Access Compliance Report

Public Rights-of-Way (Curb Ramps)

Intersection ID: 17494	Main Street: MONROE_RD	Cross Street: FOREST_WAY_DR	Location: SE
ADA ID: 38BBAB38B533	Ramp Type: Directional1	Initial Pass/Fail: Pass	Overall Compliance: No
		Severity Score: 0

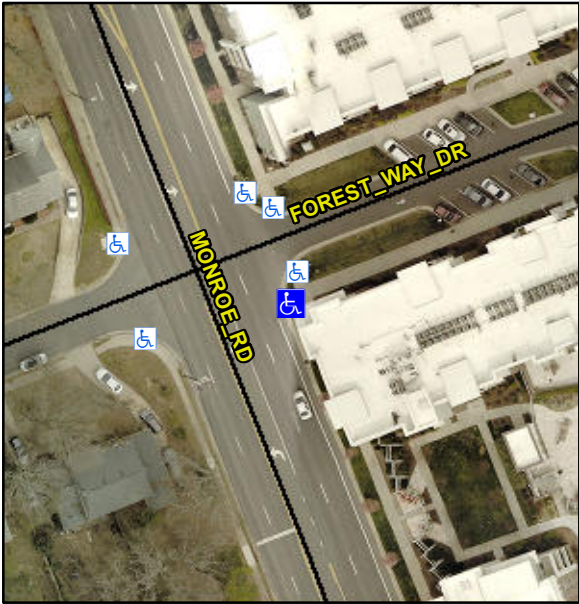
Codes/Mitigation Info/Possible Solution			Field Measurements/Component Compliance					
	Possible Solutions:		Compliance	Description	Data	Compliance	Description	Data
	Remove & Replace Entire Ramp.		N/A	Ramp Length (in)	77.0	Yes	Grade Break?	Yes
			Yes	Ramp Width (in)	73.0	Yes	Grade Break Slope (%)	0.2
			Yes	Ramp Slope (%)	2.9	Yes	Grade Break XSlope (%)	1.0
			Yes	Ramp XSlope (%)	1.0			
			Yes	Flare Type LT	N/A	Yes	Flare Type RT	N/A
			N/A	Flare Slope LT (%)	N/A	N/A	Flare Slope RT (%)	N/A
			N/A	Flare Traversable LT?	No	N/A	Flare Traversable RT?	No
			Yes	Landing Length (in)	84.5	Yes	DWS Provided?	Yes
			Yes	Landing Width (in)	73.0	Yes	DWS Contrast?	Yes
Surveyor Notes:			No	Landing Slope (%)	2.5	Yes	DWS Length (in)	24.0
N/A			Yes	Landing X Slope (%)	1.4	Yes	DWS Full Width?	Yes
PROW/ADA:			N/A	Landing Curb? (Y/N)	No	No	DWS Offset LT (in)	5.0
R304.2.2-Perp, R304.3.2-Para, R305.2			N/A	Shared Landing?	Yes	Yes	DWS Offset RT (in)	15.0

Yes	Gutter Ponding?	No	Yes	Gutter Slope (%)	2.8
			Yes	Gutter Lip Ht (in)	0.0	Yes	Gutter X Slope (%)	0.8
			N/A	Painted X Walk1?	No		Road Slope (%)	1.3
				X Walk 1 Direction	To SW		Road X Slope (%)	0.2
				X Walk 1 Width (in)	N/A		Clear Space?	Yes
				X Walk 1 Slope (%)	1.3	N/A	Clear Space to XWalk (in)	N/A
				X Walk 1 X Slope (%)	0.2	Yes	Storm Grate/Utility Hazard?	No
			N/A	Ramp inside XWalk1?	N/A		Storm Grate/Utility Type	
			Yes	Any Obstructions?	No			N/A
				Obstruction Type		Yes	Surface Condition? (G/P)	Good
						N/A	Curb Slope (%)	3.5
Street 1 Name		MONROE RD						
Stop Condition-Street 1		None						
Street 2 Name		N/A						
Stop Condition-Street 2		N/A						
Total Cost:		\$ 1600.00
